24th February 2021

Council of City of Gold Coast

Objection submission COM/2019/81 - Traffic Impact Assessment(s) highly flawed

Attachment B4 - State Principle Cycle Network and Nucrush quarry transport route converging throughout the area surrounding the quarry and transport route (Red circle)

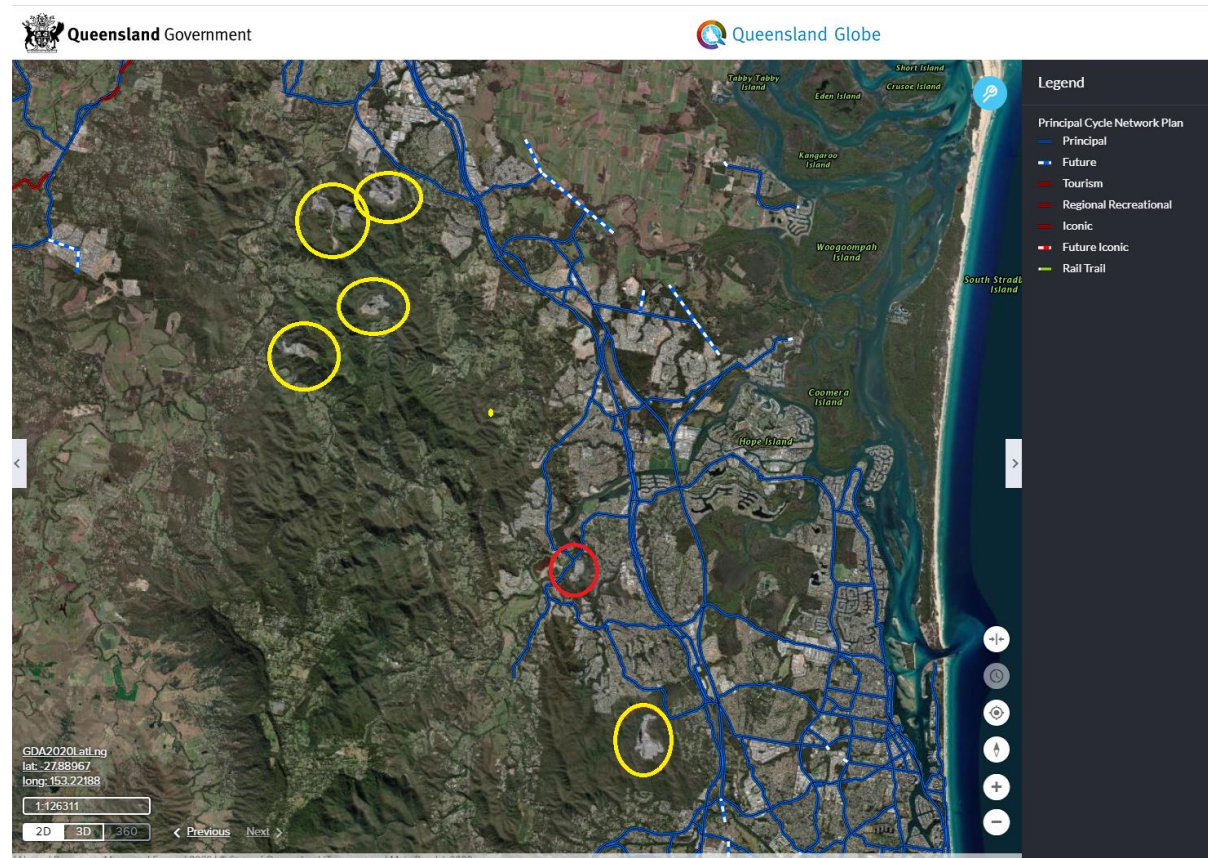
Please note the most widely used transport route by the quarry (for 85% of journeys) traverses through a busy local suburb for 4km to the Pacific motorway. The remaining 15% travel south from the site or west to the sister Nucrush site at Hart Street, Upper Coomera or to the hinterland beyond. All of this quarry's 'transport route' is mainly a single lane (in each direction) without pedestrian pathways or cycle ways (despite also being the 'Principle Cycle Network, see attachment B4).

Attachment G3 - Applicant site map with no space for car parking facility

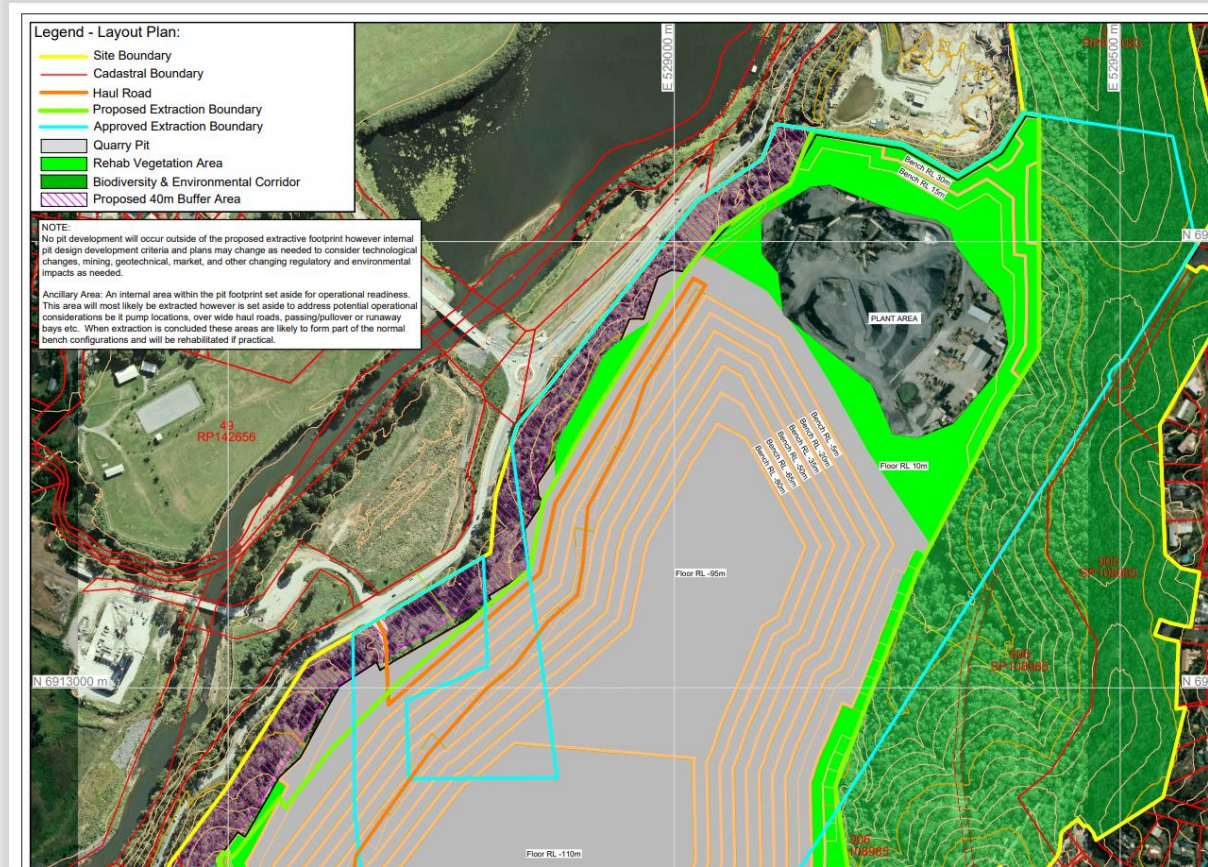
The applicant has failed to provide a car parking assessment as required. The latest submission attempts to demonstrate car parking for each stage as is required. However, Stage 6 onwards it is awkwardly squeezed in between the extractive footprint and the proposed Plant area. In fact the newly define car parking/truck parking impinges on the plant area. Also, the concrete production /batching area does not have adequate room to operate and the entry and exit to the facility will also impinge on the plant area and proposed parking area. Entry and exiting this facility will also clash with the plant area front end loaders, the haulage trucks and the general quarry operation. Clearly there is not enough room given the extractive footprint proposed for the operations required.

The applicant has failed to: “Submit a car parking assessment that identifies the existing peak car parking demand on the site” as required, and the submitted drawings are, I believe, inadequate for the task in hand.

Attachment I1 - Traffic Impact Assessment, Section 2.3 Surveyed Traffic Volumes

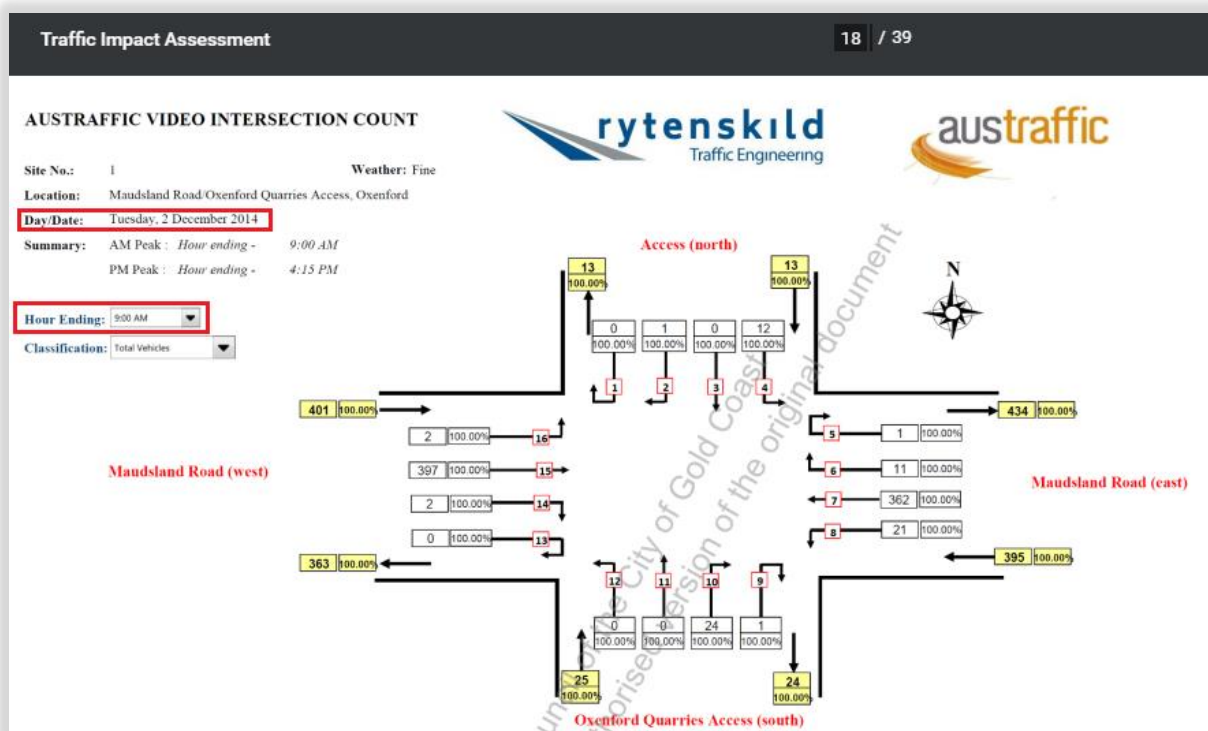
The Surveyed Traffic Volumes (attachment I1) states: “Traffic Counts carried out by Austraffic at the Maudsland Road / Nucrush site access intersection (in 2014) are provided as Attachment B (and discussed further in Section 4)” . However, these surveyed traffic estimates are woefully inadequate and truly shameful. They are based on just two hours of traffic counts back on 2nd December 2014, one being 8:00am to 9:00 am (Attachment I2) and the other being 3:15pm to 4:15pm (Attachment I3). That is the total surveyed traffic volumes which is not even the peak operating times for the quarry. A mere two hours of data!

Not only is this development application basing their future “Development Traffic Estimates” on just a two hour survey, seven years ago, it is also basing it on an output production of approximately half of last year’s output (430k as opposed to 825k) and it must be remembered this development applications proposal is to increase this to 1,000,000 tonnes per annum. Therefore, the “Development Traffic Estimates” are approximately forty three percent of the development traffic this development application is proposing. Or, to put it another way, the development traffic that is claimed as a result of this development application will be nearly two and a half times what this traffic impact assessment is claiming.

Attachment I4 - DA Submitted Quarry production graph (2014 highlighted)

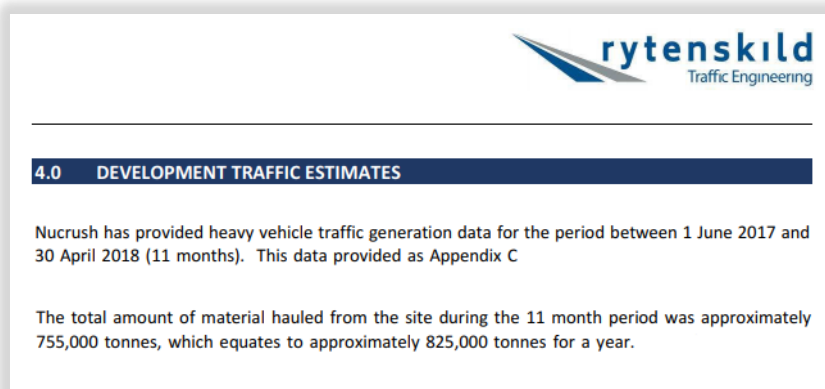
It is also culpably negligent in using a selected single day in the year that represents the lowest production in the last twenty years since production started (assumed to be 2001) at approx. 430,000 tonnes (as shown in attachment I4), well below the claimed average of 600,000 tonnes and a shadow of last years claimed 825,000 tonnes (Attachment I5).

Attachment K2 - Bullrin (or JGI) Quarry entrance 34 Maudsland Road

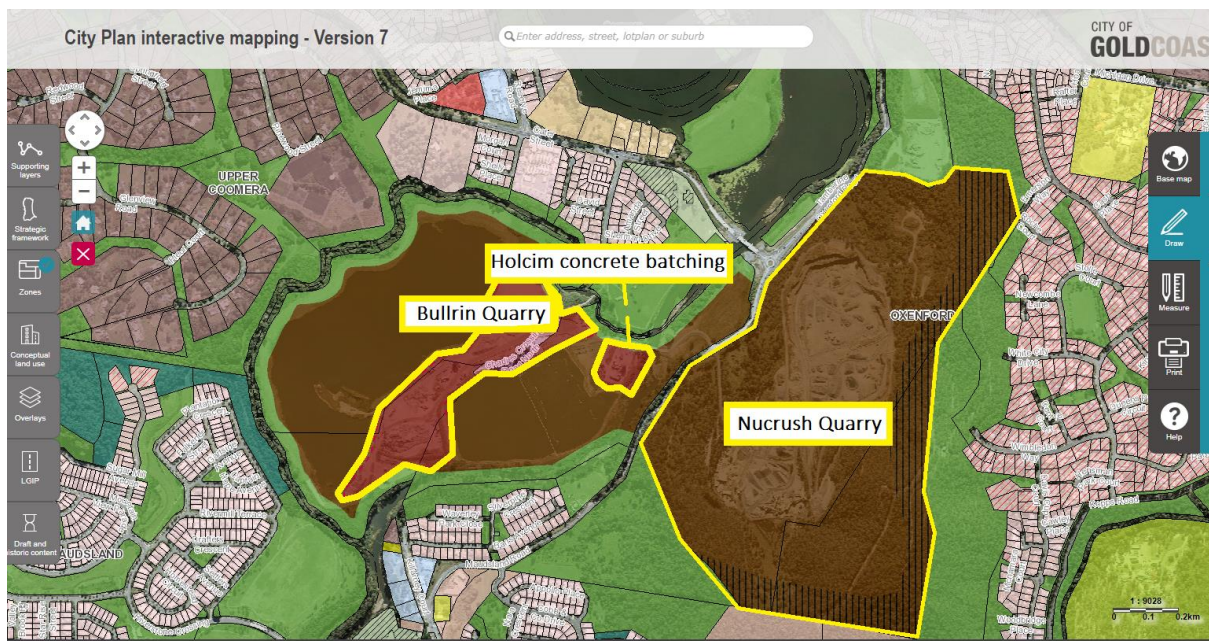
The Traffic Impact assessment shows the site access in Figure 2.3 (attachment K1). It culpably neglects, however, to reveal that the “Wave Park” entrance opposite at 34 Maudsland Road is also the entrance to the Bullrin (or JGI) quarry, also at 34 Maudsland Road (Attachment K2) and also the Holcim Concrete production / batching plant also at 34 Maudsland Road (Attachment K3).

Attachment K6 - Road layout Maudsland road at Nucrush quarry, Bullrin quarry and Holcim entrances

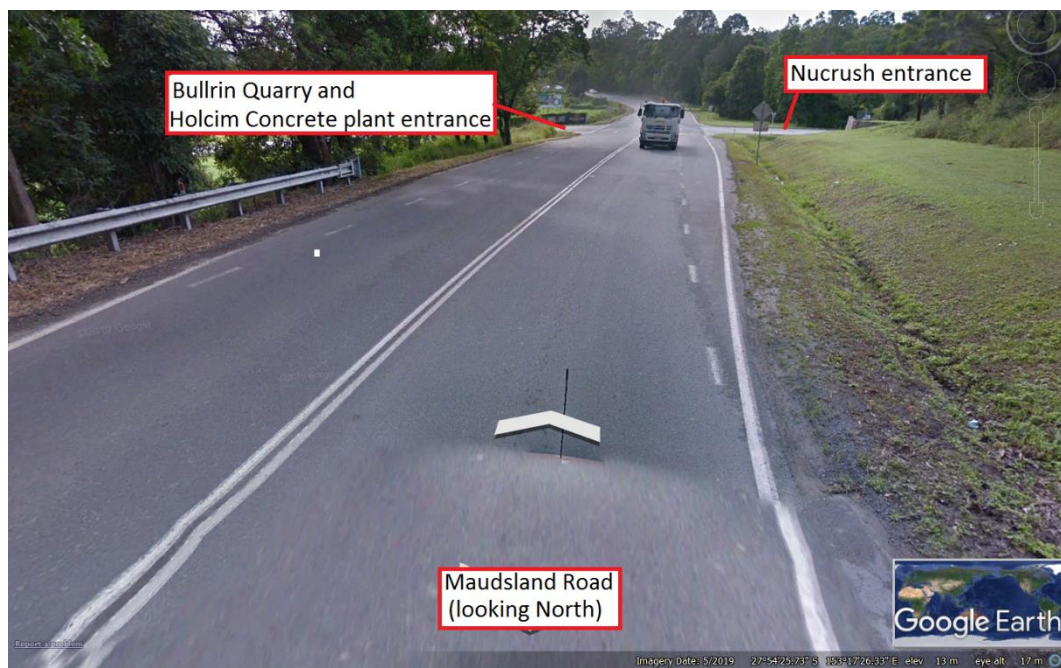
There is no dedicated **“right hand turn lane”** neither is there an **“existing passing lane”**. There is only a combined ‘Deceleration lane’ and an ‘Acceleration Lane’ on either side of the intersection, enabling exiting and merging on to the Maudsland road from the Nucrush and Bullrin quarries and the Holcim concrete batching plant and the Wake Park and the Aqua Park entrances safer and smoother (as shown in Attachment K6). The function of the ‘Deceleration lane’ and ‘Acceleration Lane’ is described in Chapter 15 of the Qld TMR Road Planning Design Manual and is reproduced in Attachment K7.

This attempted redefinition of the intersection means data supplied to the software model is incorrect. It should go without saying that if you provide incorrect data into the modelling software the results will be incorrect too.

Attachment L1 - Accidents on the Transport route heading north and west from the quarry

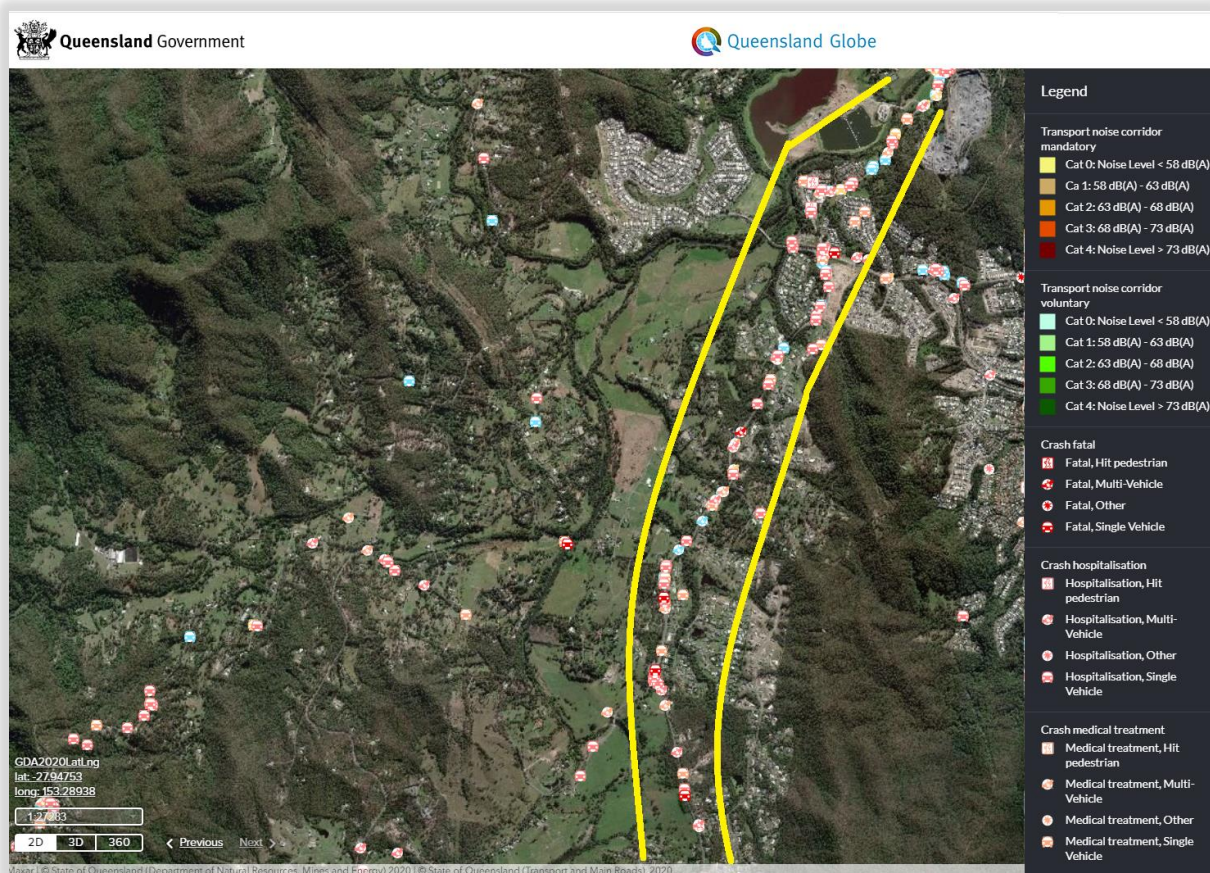
If you view the accident map for the transport route heading north and west from the quarry it is clear to see there have been a number of accidents in the vicinity (Attachment L1).

Thus, I find it unbelievable that the Traffic Impact Assessment has failed to include any safety analysis whatsoever for the Transport route used by the quarry. I also find it unbelievable that the TMR referral and the Council Information Request failed to highlight this glaring oversight.
